PLANNING COMMISSION MEETING

RE: Cosmo's Car Wash- Preliminary Site Plan Review – 2nd Review

RE: Cosmo's Car Wash
Preliminary Site Plan – Review #2

RE: Black Rock
Preliminary Site Plan and Special Land Use – Review #2

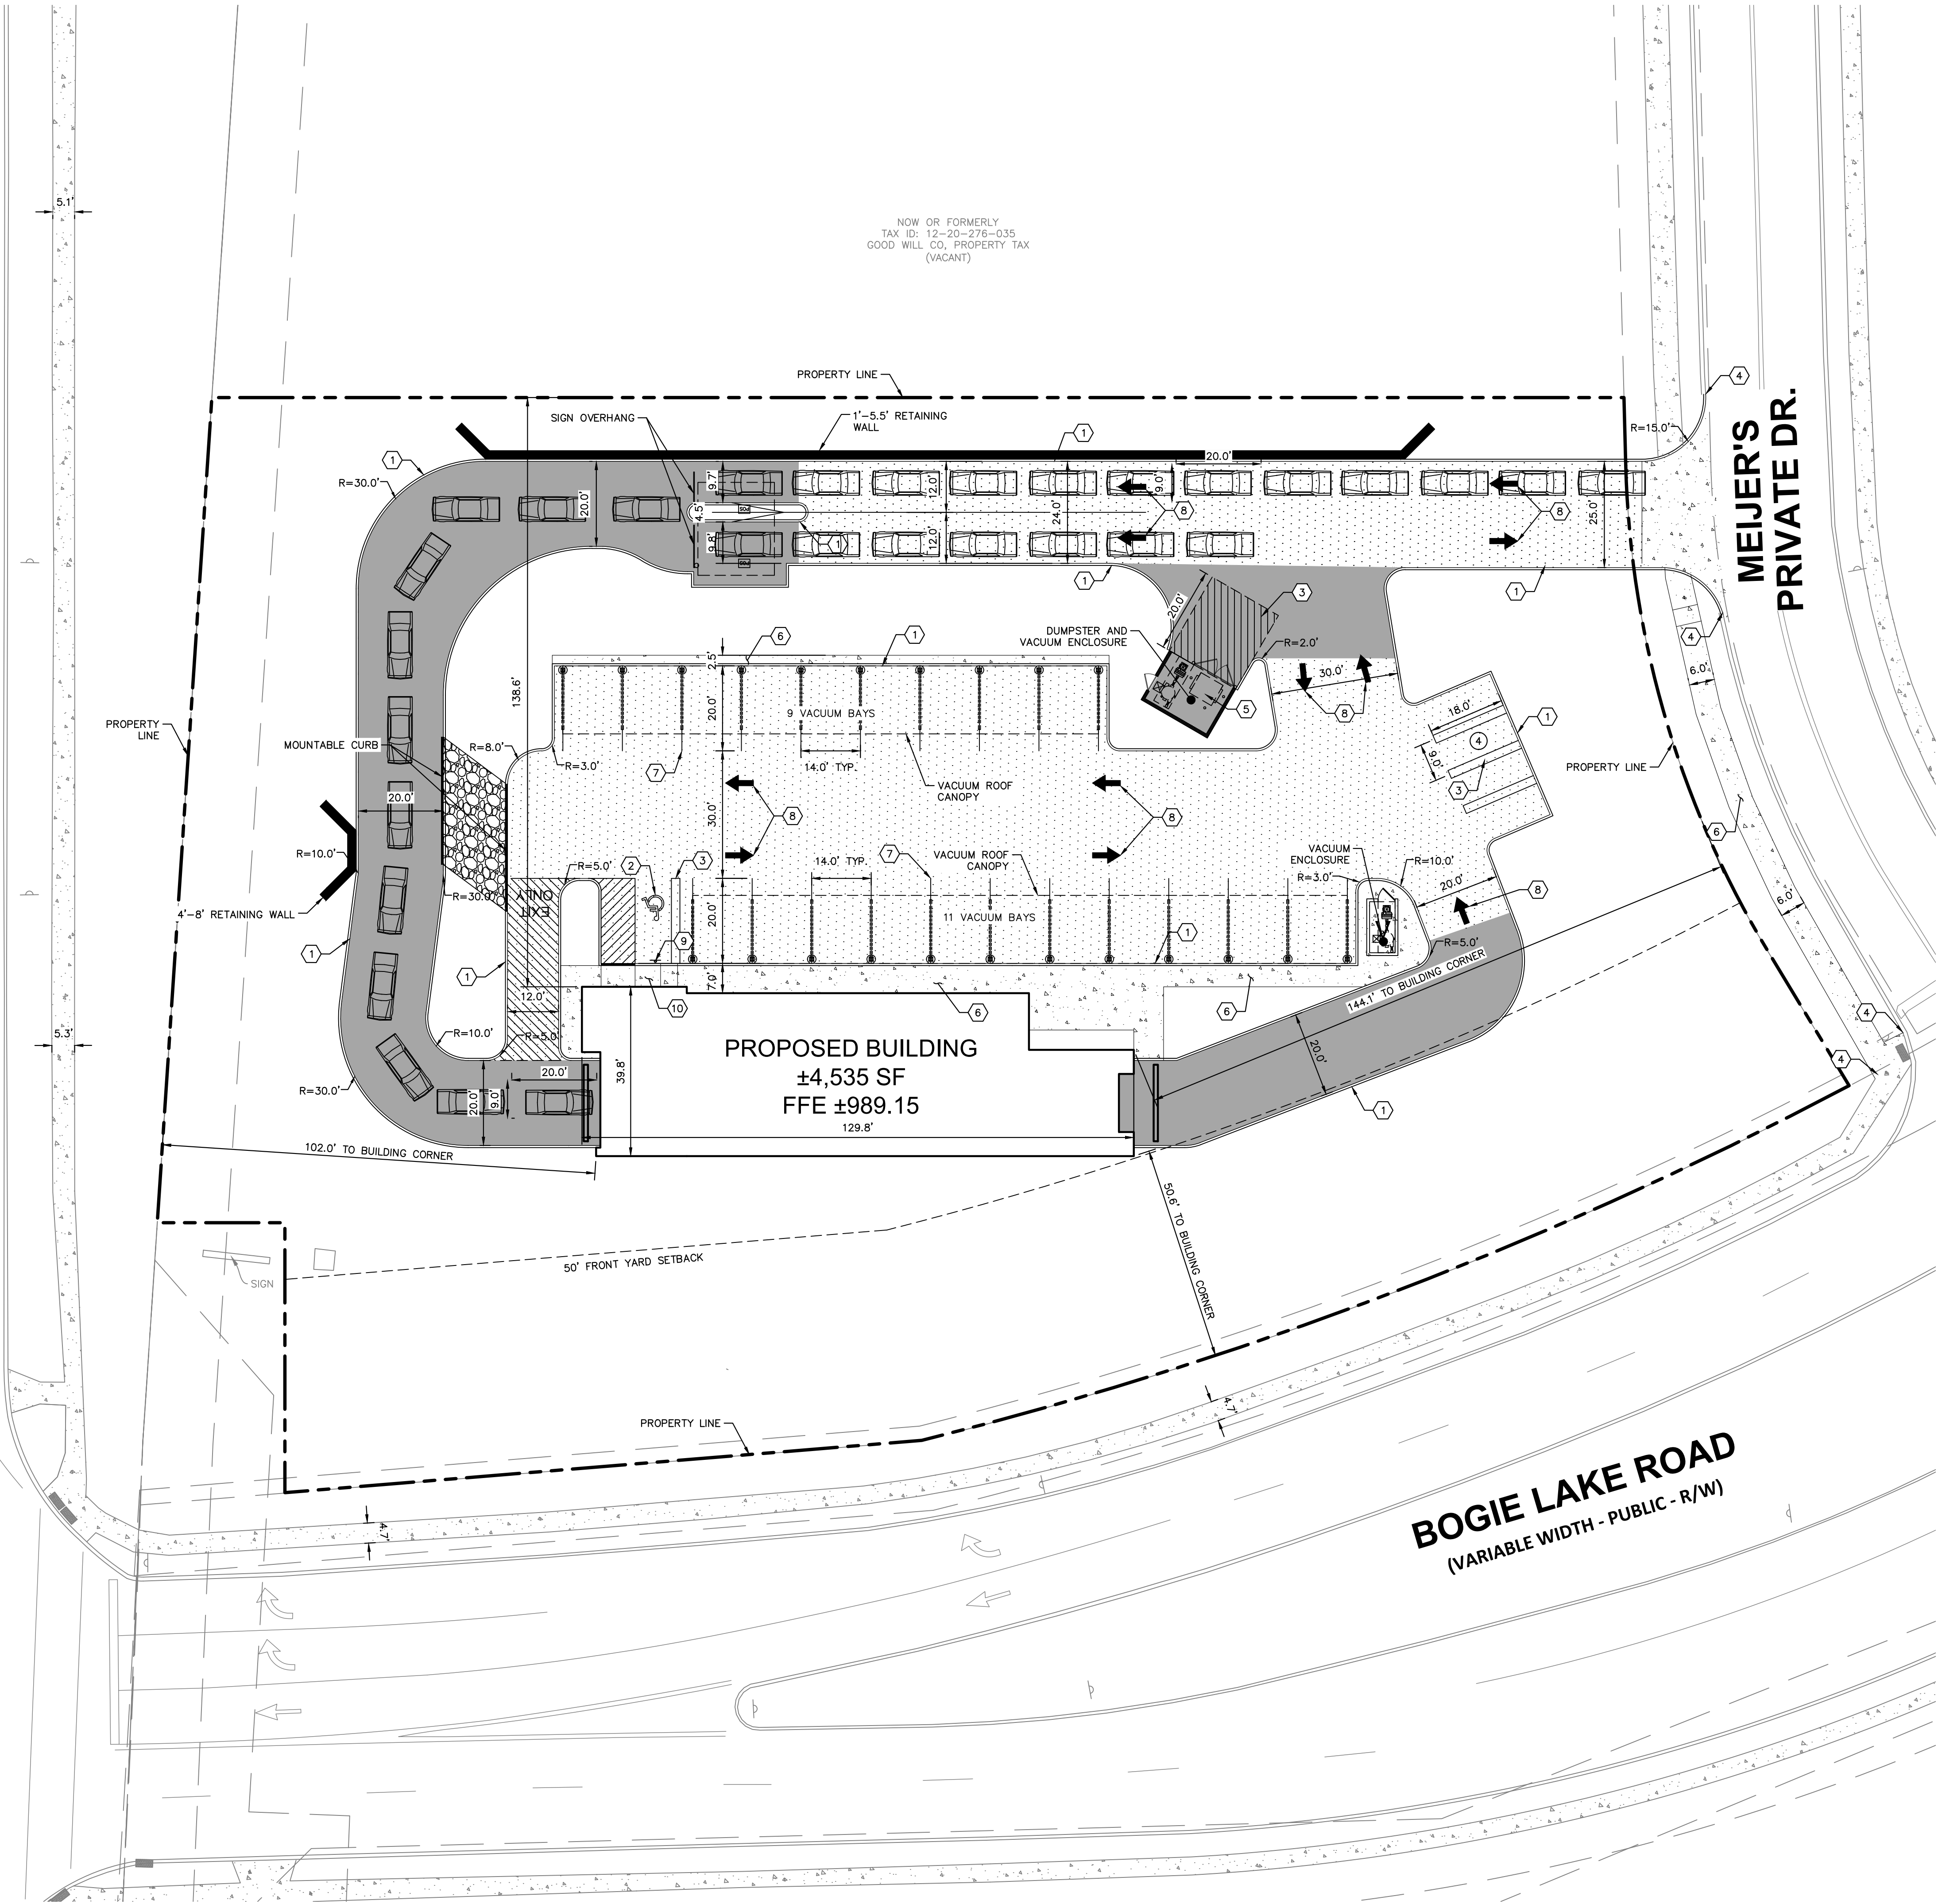
- e) *Additional details regarding the dumpster enclosure shall be required as outlined in Zoning Ordinance 5.19.N.i. a-d. Detail shown on architectural drawing is insufficient.* **Comment partially addressed. Items a.-c. of Zoning Ordinance 5.19.N.i. have been provided; however, Item d. details have not been shown on Site Plan Sheet C1.0 as indicated by the design engineer in their response letter.**

- g) *Referencing Key Note 3 on Site Plan Sheet C1.0, dual parking lot striping is required per Zoning Ordinance 5.11.Q. xi.* **Comment addressed. Detail has now been provided on Sheet C6.0.**

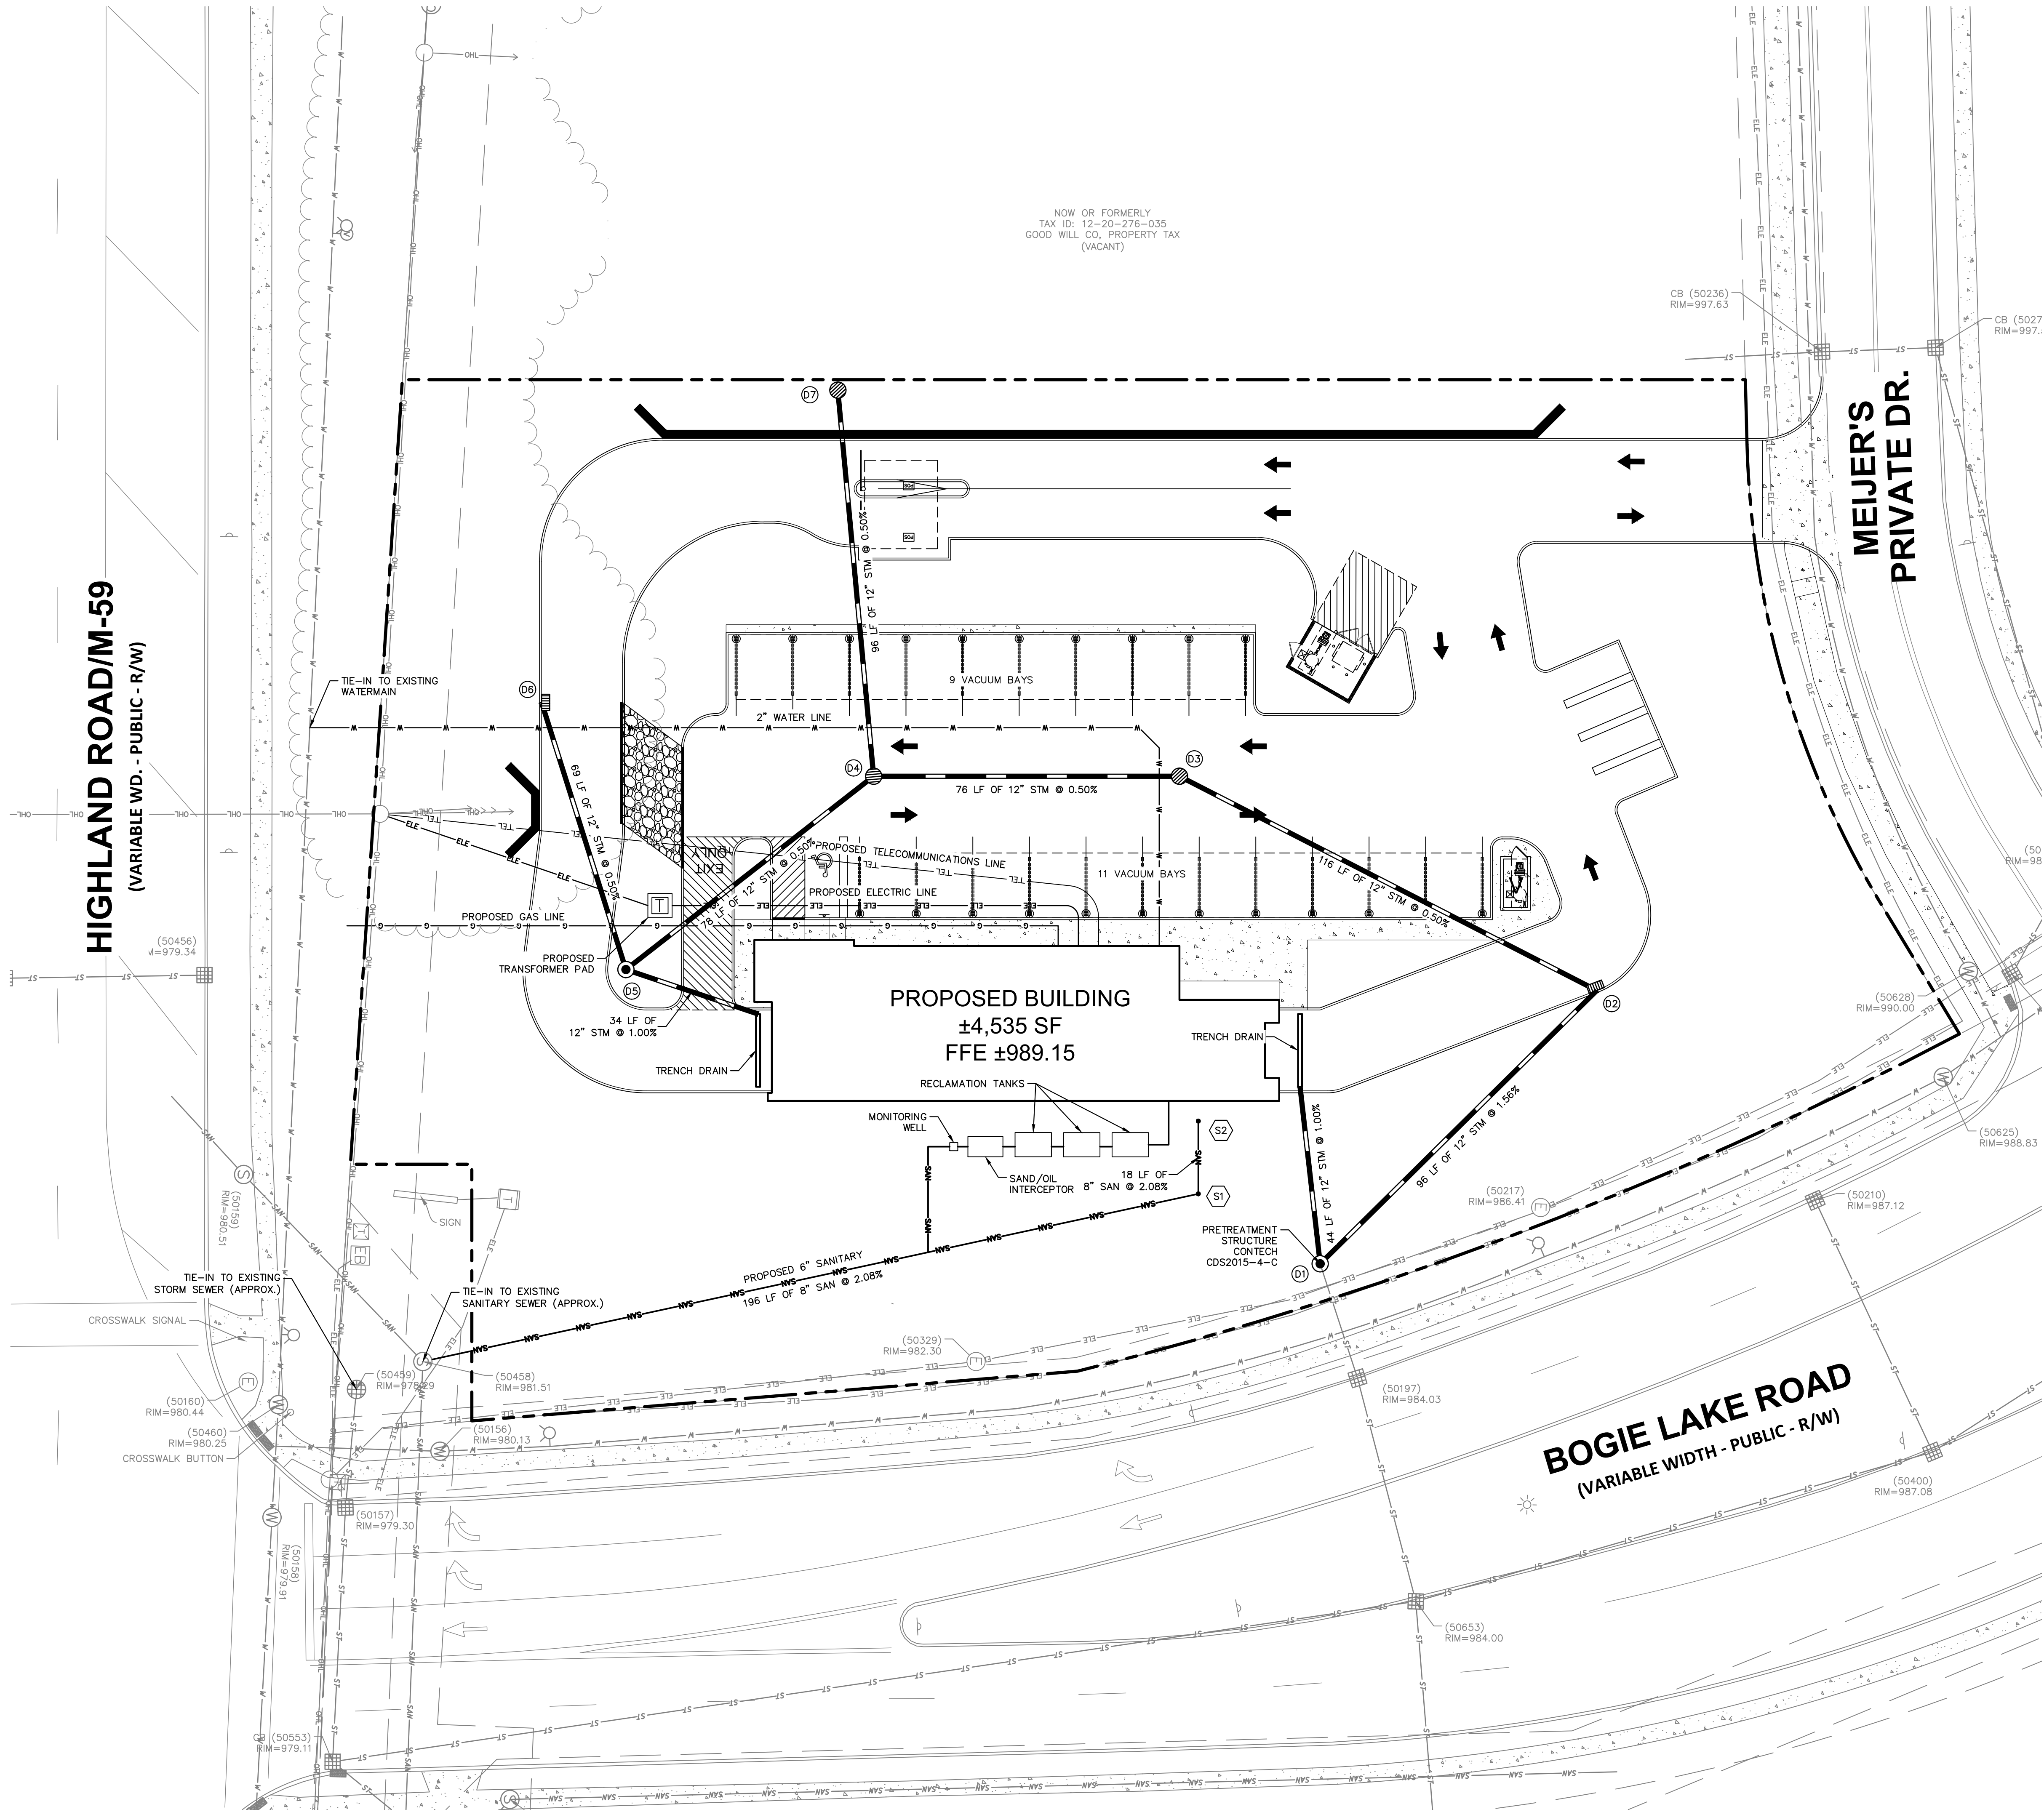
- m) *The proposed sanitary sewer pipe diameter shall be required to be 8" diameter (8" required if pipe length > 150'). **Comment partially addressed. An 8" diameter pipe is now indicated; however, remove reference to 6" diameter pipe from S1 to Ex. MH on Sheet C3. 0.***

Note 1 on C3.0 indicated $\geq 3"$ CL 52 DI pipe. Township standard is CL54 DI Pipe though I did not see any new water main proposed on this plan. The service is shown as 2" and may be K type copper or DR-9 (200 PSI) Poly meeting ASTM D2737-03 specification.
